October 22, 2020
File No. 17-405.200

**Subject: Response to City of Mercer Island Review Comments
8251 West Mercer Way, Mercer Island, Washington**

Figure 1: Bearing capacity factors for a strip foundation located at the top of a slope, where β is the angle of the slope from horizontal.

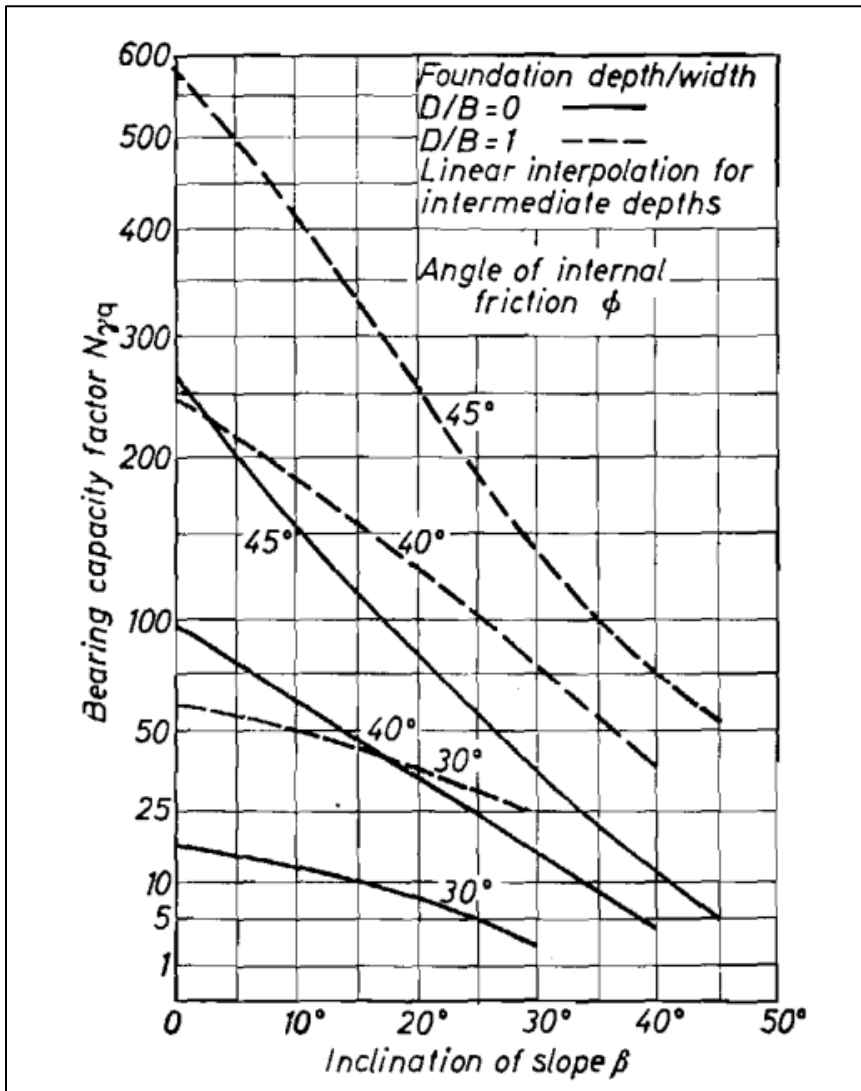
Review Comment: Page 24, No. 1, SUB 4: A reduced bearing pressure was not included in the design of the foundations in the crawl space, as required with the sloping ground conditions as shown on sheets A5.01 and A5.02. Geotechnical engineer to provide specific recommendation for bearing pressures to be used for this sloping ground condition or provide additional embedment requirements for the footings. Footing sizes to be modified as needed with the reduced bearing pressure or show additional embedment requirements for the footings located on sloping ground.

Response: Some of the footings in the crawl space of the residence will be located on or at the top of a slope that is as steep as 2½H:1V (Horizontal:Vertical) and up to 10½ feet tall. We used the following Meyerhoff equation for ultimate bearing capacity of a footing on a slope to evaluate the bearing capacity of the soils based on the footing configuration:

We evaluated the allowable bearing capacity using the current foundation layout with no setback and no embedment ($N_{yq} = 28$) and calculated an allowable soil bearing capacity (factor of safety of 3.0) of 2,800 psf for the current foundation configuration.

In order to achieve a factor of safety of 3.0 for the design allowable soil bearing pressure of 3,000 psf, the footing should be setback at least three feet from the face of the slope at the footing invert elevation ($N_{cq} = 0$ and $N_{yq} = 35$).

Based on our additional analysis, we recommend embedding the footings such that they have at least three feet of horizontal setback from the face of the crawl space slope at the elevation of the footing in order to achieve the recommended allowable soil bearing capacity of 3,000 psf.

Alternatively, a maximum allowable bearing pressure of 2,800 psf could be used for the current foundation configuration.
